## ADDENDUM | No. 1

<b>PROJECT</b>	Campground Development – Phase II, Palisades State Park, Minnehaha County, SD, GPF Project No. Pali220a, OSE#G2121—12X/DEL		
<b>BID DATE</b>	3:00 PM	CT	5/5/2022
<b>BID LOCATION</b>	Department of Game, Fish and Park Engineering Section Foss Building, 523 East Capitol Above., Pierre, SD 57501-3182 Video Link: <a href="https://gfp.sd.gov/bids-contracts/">https://gfp.sd.gov/bids-contracts/</a>		
<b>ISSUE DATE</b>	5/3/2022		
<b>NOTICE</b>	Failure to acknowledge all addenda in the BID may cause rejection of the BID. See Instructions to Bidders.

## BID FORM - ADDENDUM NO.1

# OVERALL SOIL BORINGS

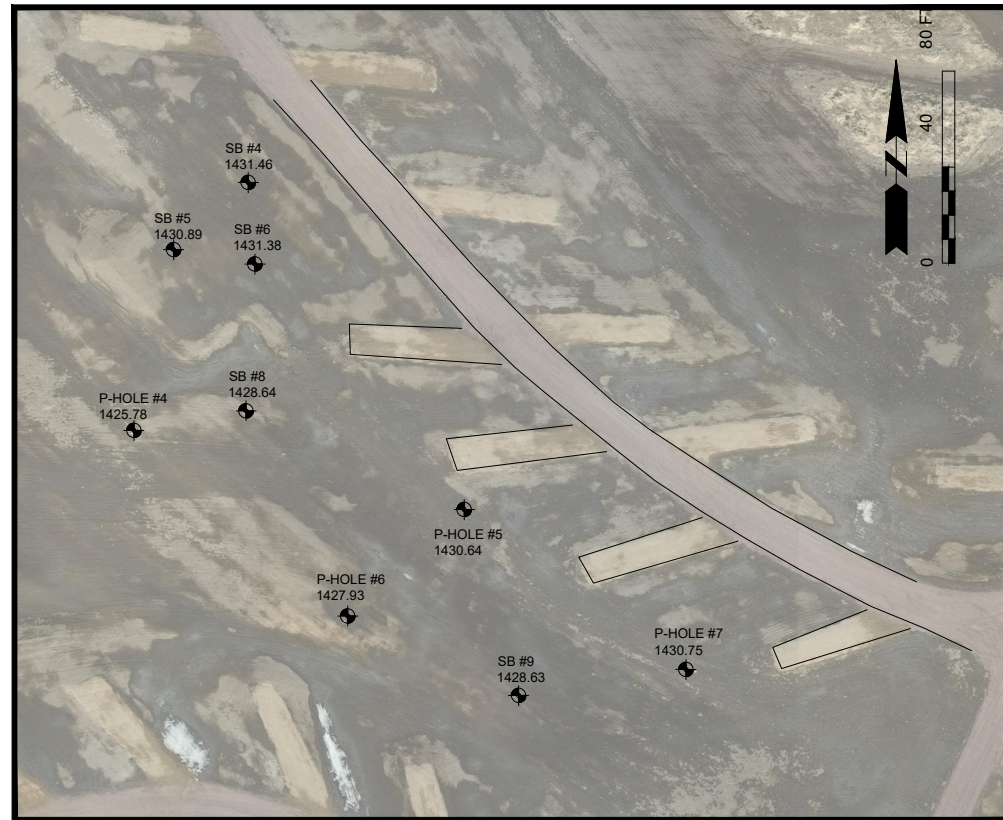
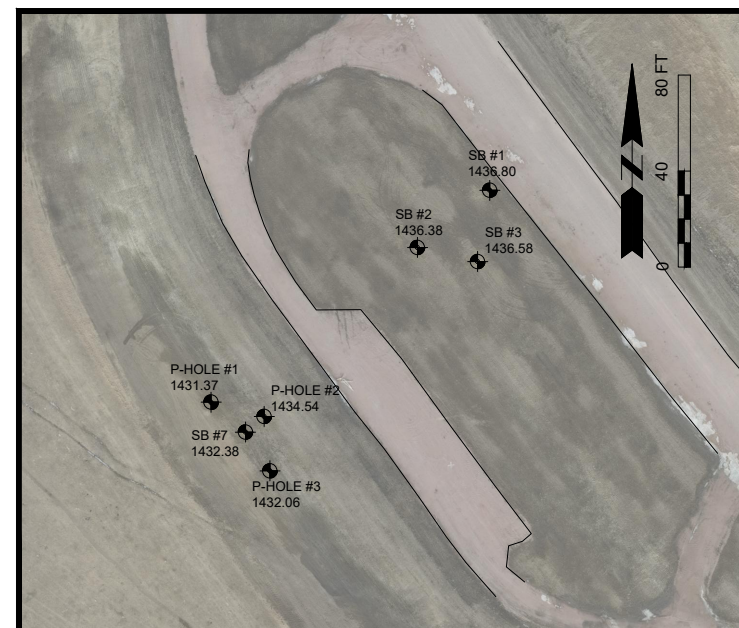
*Add:* Additional geotechnical exploration sites in Dump Station Area with date 4.25.22
